Final Basis of Design Report

Lapwai Creek Reach 14
Floodplain and Habitat Restoration
Nez Perce County, Idaho

for
Nez Perce Tribe

Appendix G. HIP Project Review Comment Tracking

LAPWAI CREEK REACH 14 FLOODPLAIN AND HABITAT RESTORATION
NEZ PERCE COUNTY, IDAHO
EXISTING CONDITIONS PLAN AND PROFILE

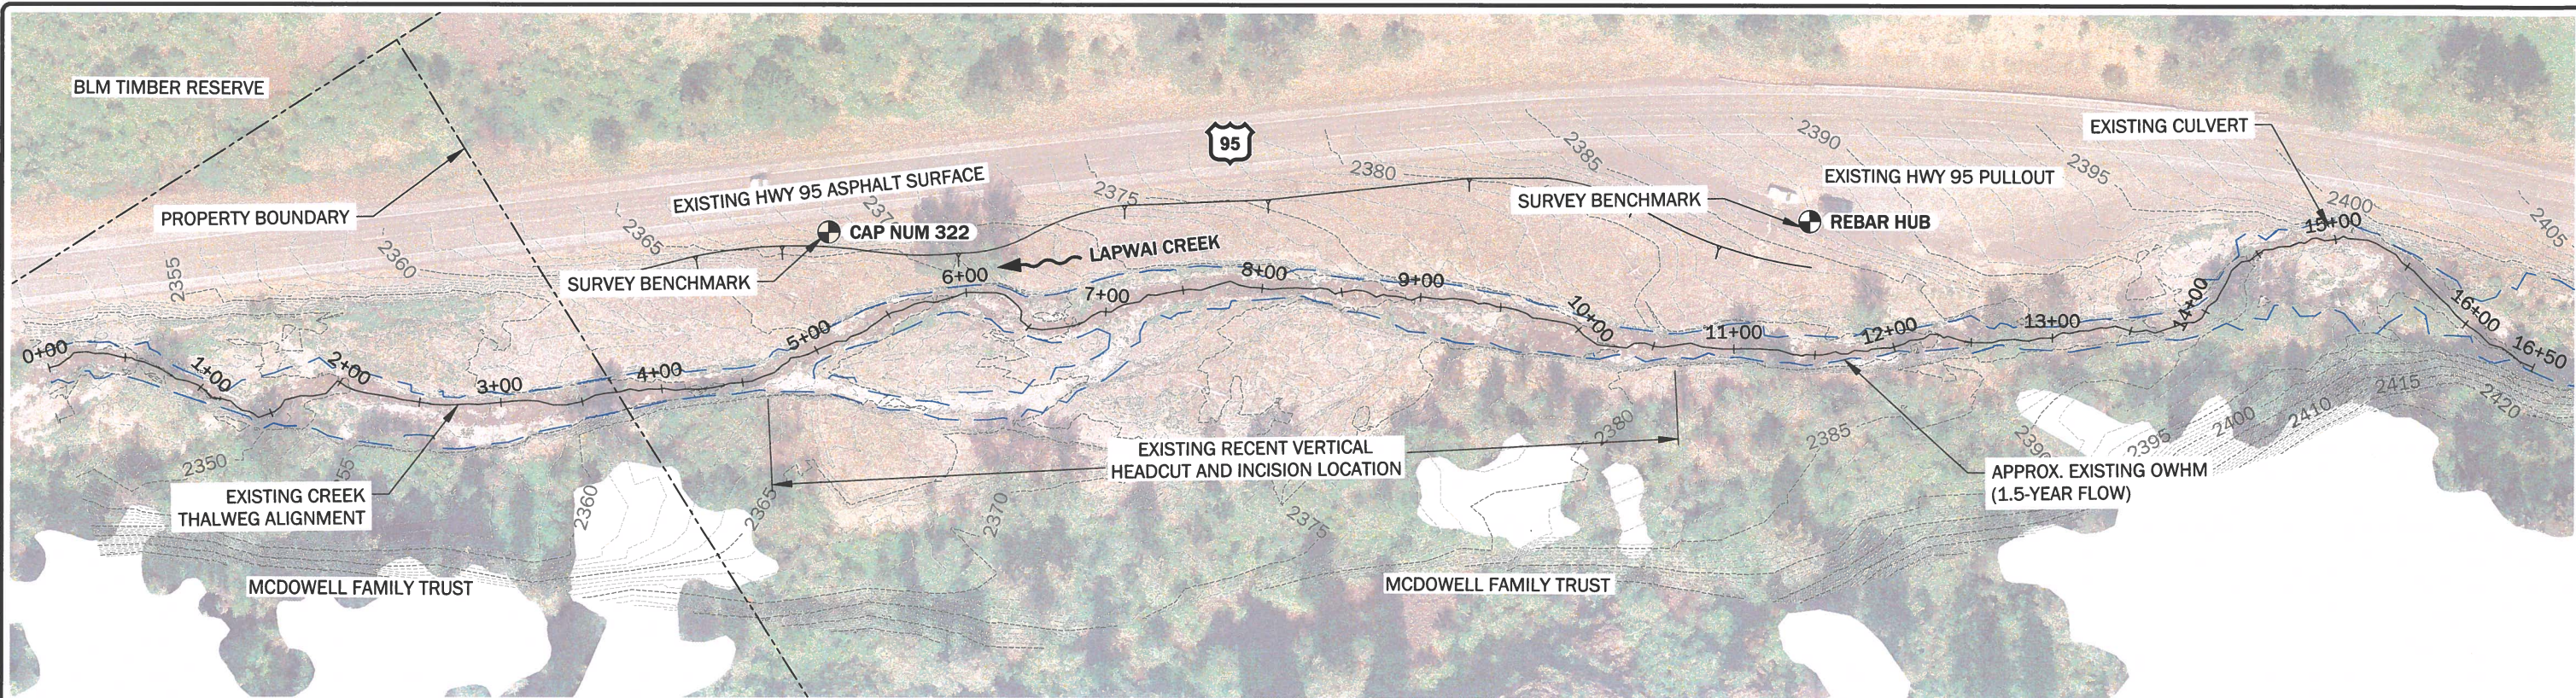
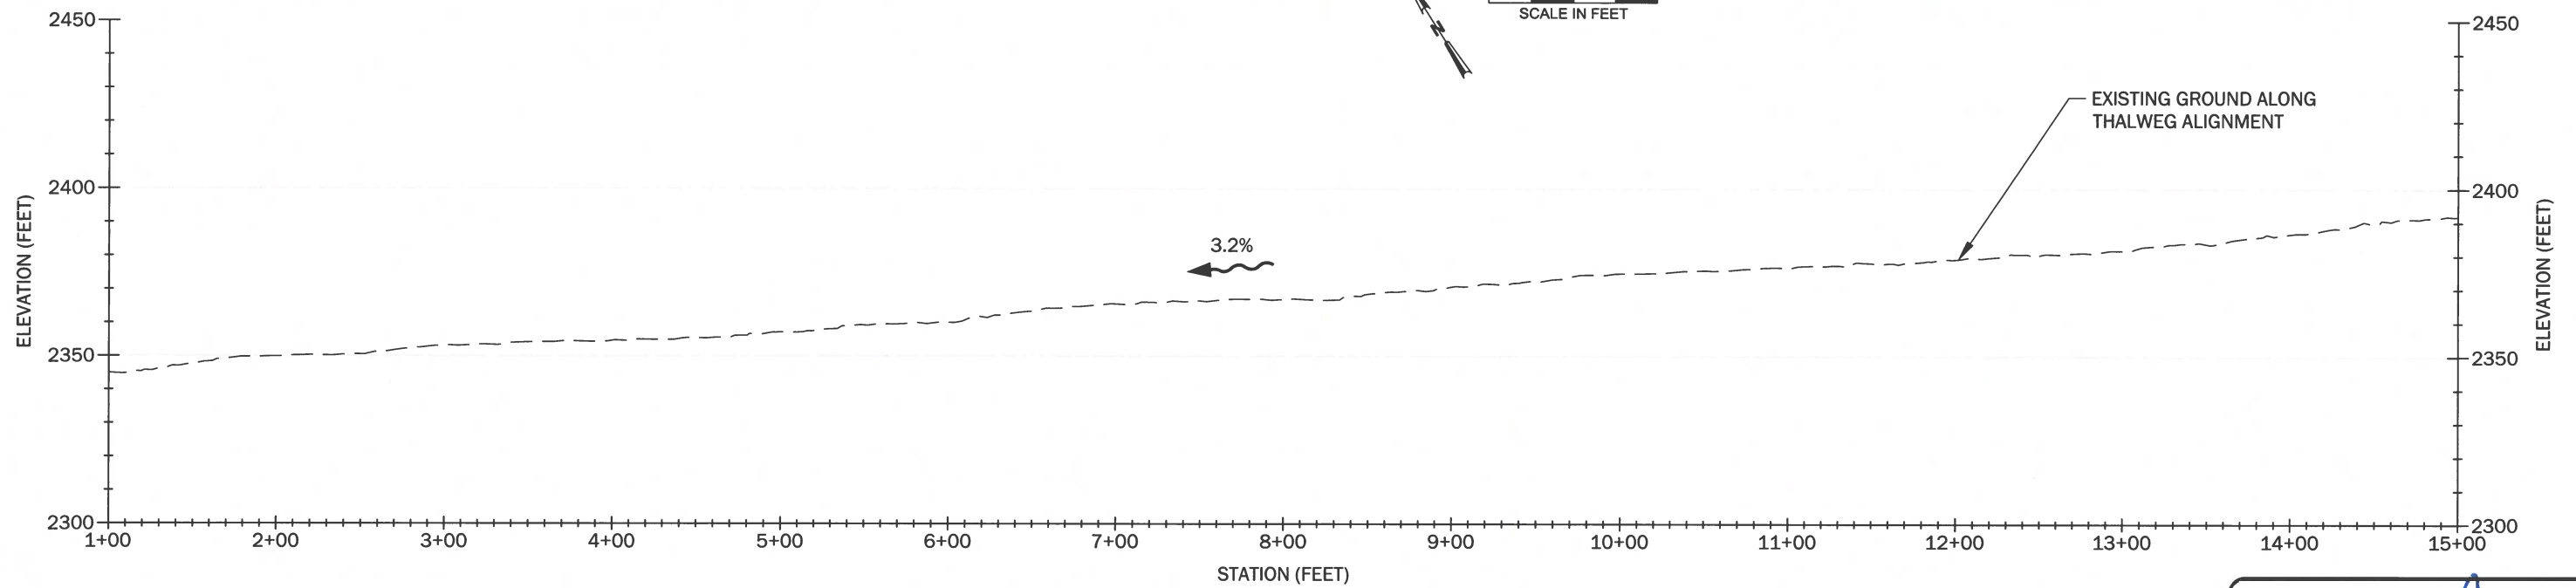
14	BPA	9/3/21	BOD	Drawing 2.0	Non-HIP comment for NPT to address: Drawing 2.0 shows property ownership. Does this show that the underlying land is private, but project is within ITD ROW? We've talked about needing agreements with IDT for use of the pullout for staging. What other agreements are needed/planned?	NPT	9/30/21		Not a HIP review comment
15	BPA	9/3/21	BOD	Drawing 3.0	Non-HIP comment for NPT to address: please provide a .shp file of the Project Disturbance Limits to the EC Lead to compare the APE with the 2018 project to figure out if additional cultural resource survey will need to be scheduled before implementation planned for next year.	NPT	9/30/21		Not a HIP review comment

PROPOSED CHANNEL TYPICAL SECTION
NOT TO SCALE

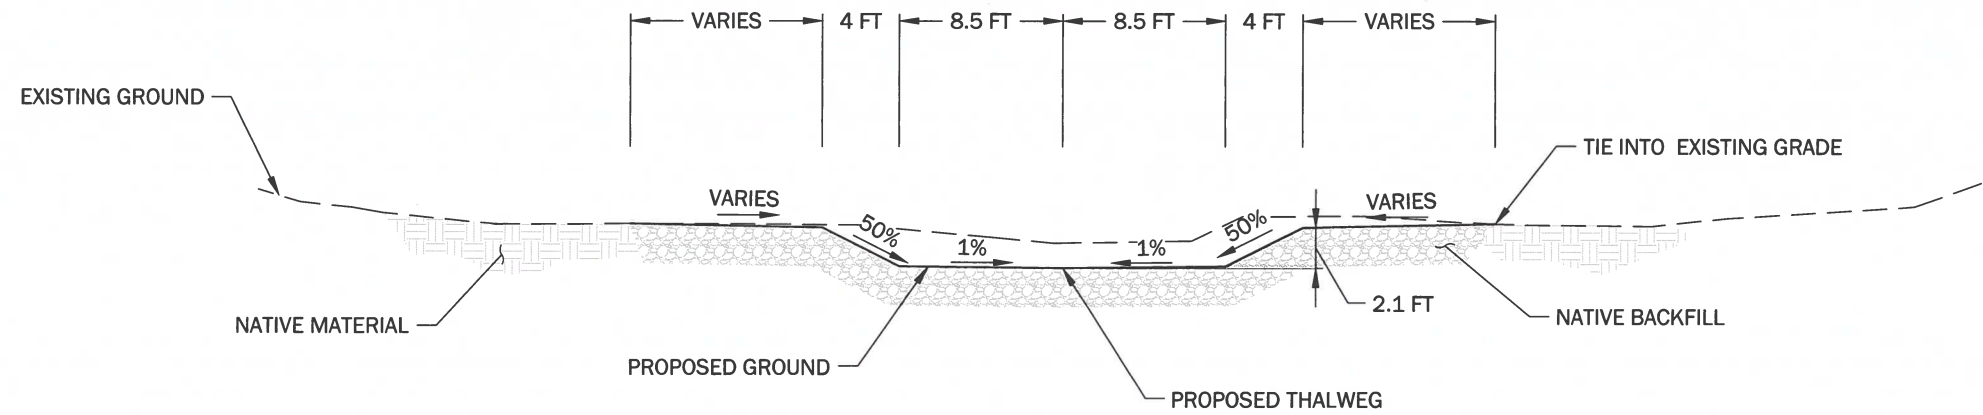
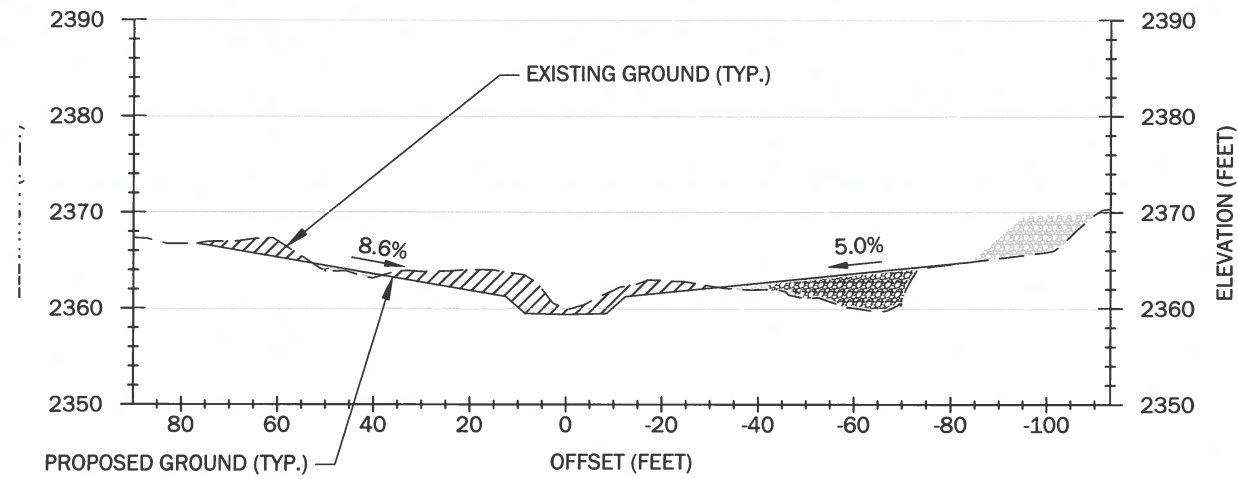
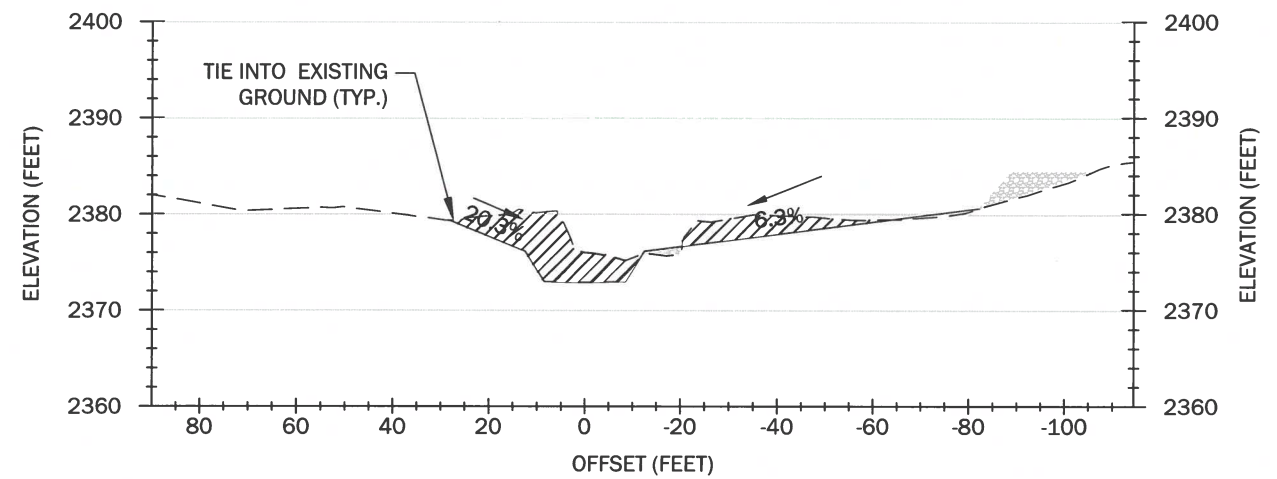
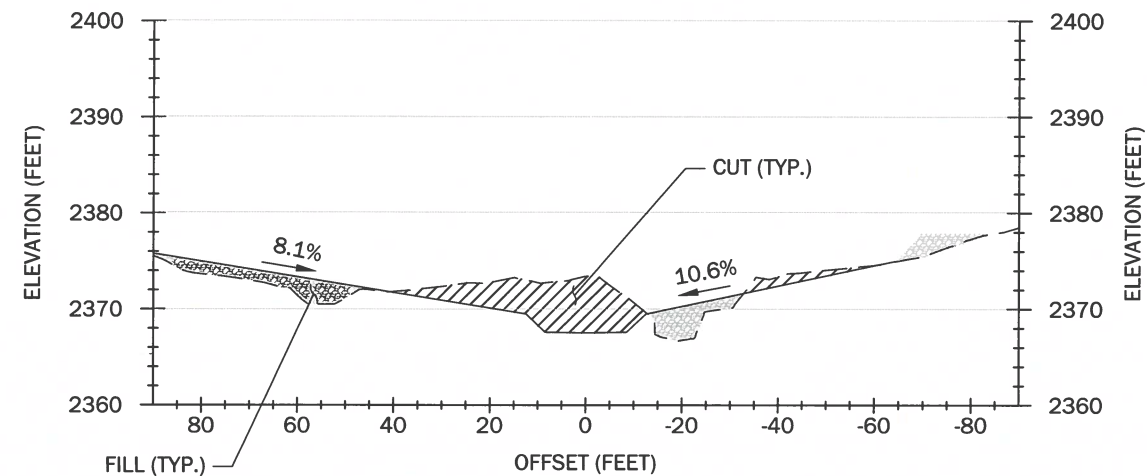
11	BPA	9/2/21	Plans	4.1	Recommend removing the 50% slope from typical channel detail on sheet 4.1 and state "varies". The math doesn't line up if intent is 32 ft top of bank consistent with horizontal length summation and detail on sheet 5.3.		GeoEngineers	9/15/21	The final design drawings have provided approximate cross-sectional side slopes and maximum allowed where appropriate.	Open (Recommendation)

PROPOSED CONDITIONS STRUCTURES PLAN

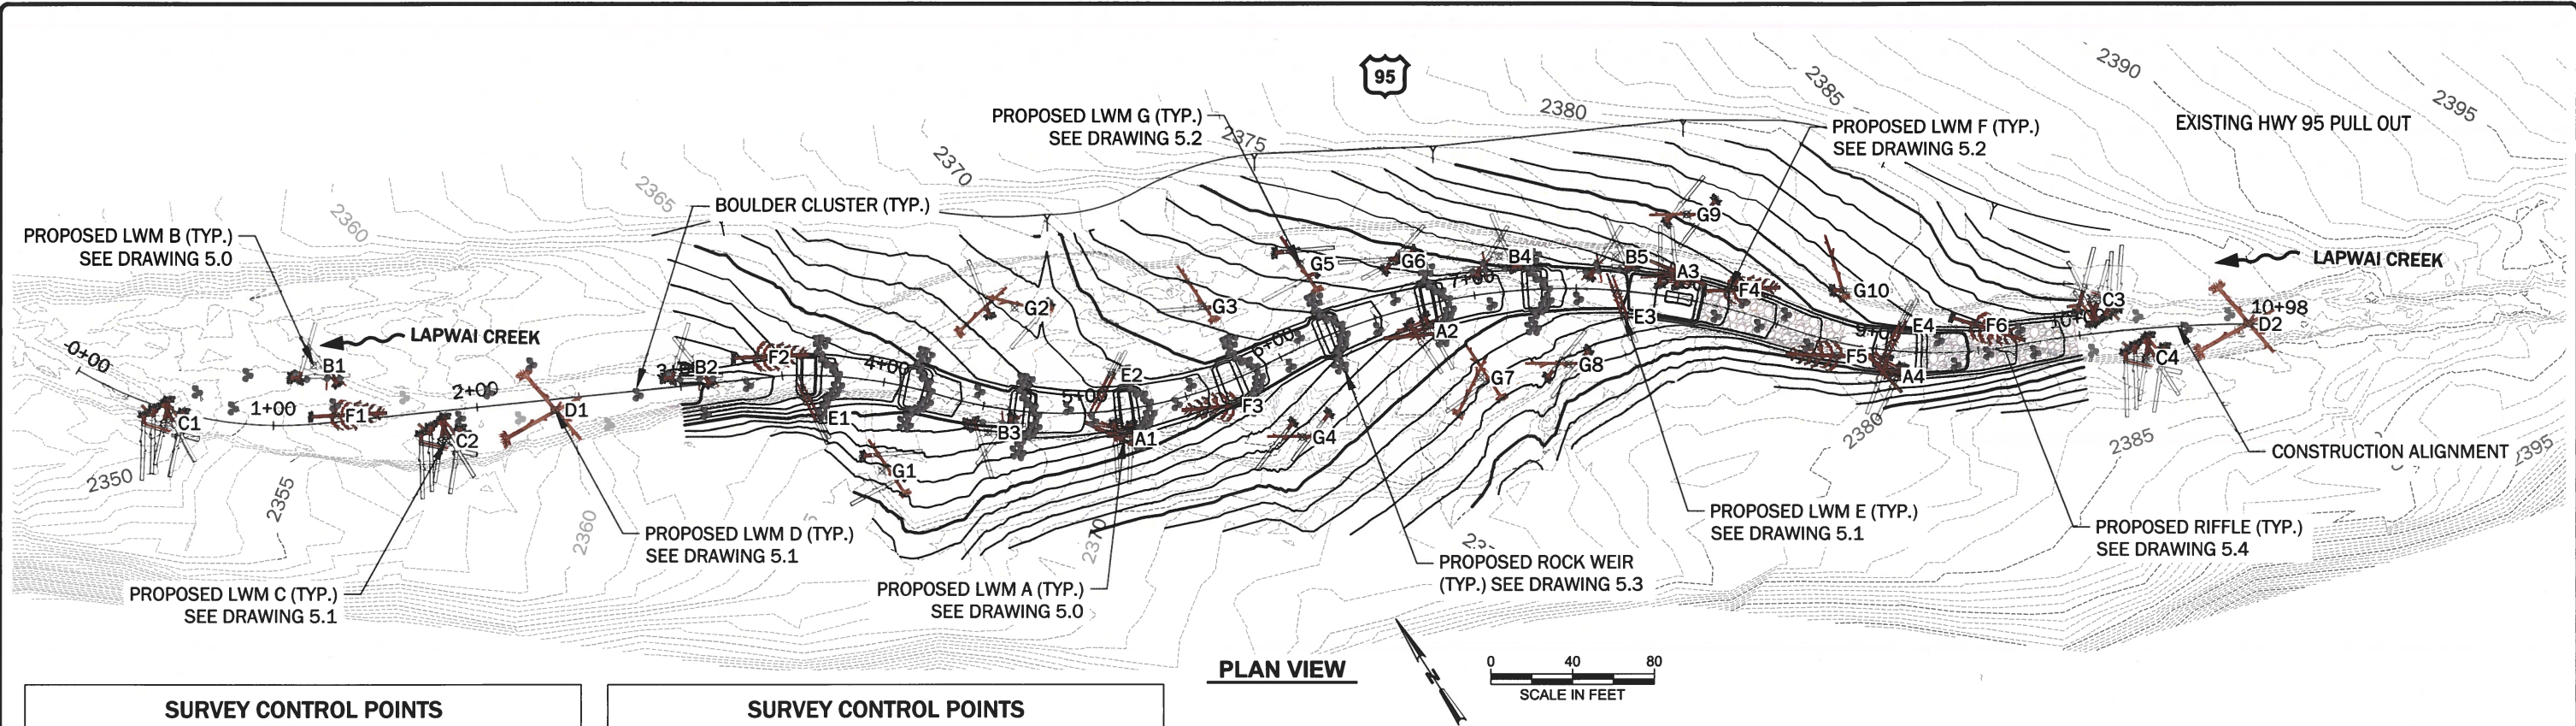
9	BPA	9/2/21	Plans	4.2	Please add a road width specification to plan sheet 4.2 to supplement the wood schedule.		GeoEngineers	9/14/21	The final design drawings include specifications for road width dimensions and acceptance of large wood material to be determined by the contracting officer. We are recommending road width size to be 2x DBH.	Open (Recommendation)
10	BPA	9/2/21	Plans	5.3	Please add additional clarity to the boulder diameter specification on sheet 5.3. The current statement would allow all 24" boulders. Recommend stating a minimum % of each intended class. Recommend specifying Footer Boulders separate from Header Boulders to align with plan call-outs.		GeoEngineers	9/14/21	The final design drawings include specific footer and header boulder size requirements. The design drawings also identify the percentage by weight for specified size classes for the boulders.	Open (Recommendation)
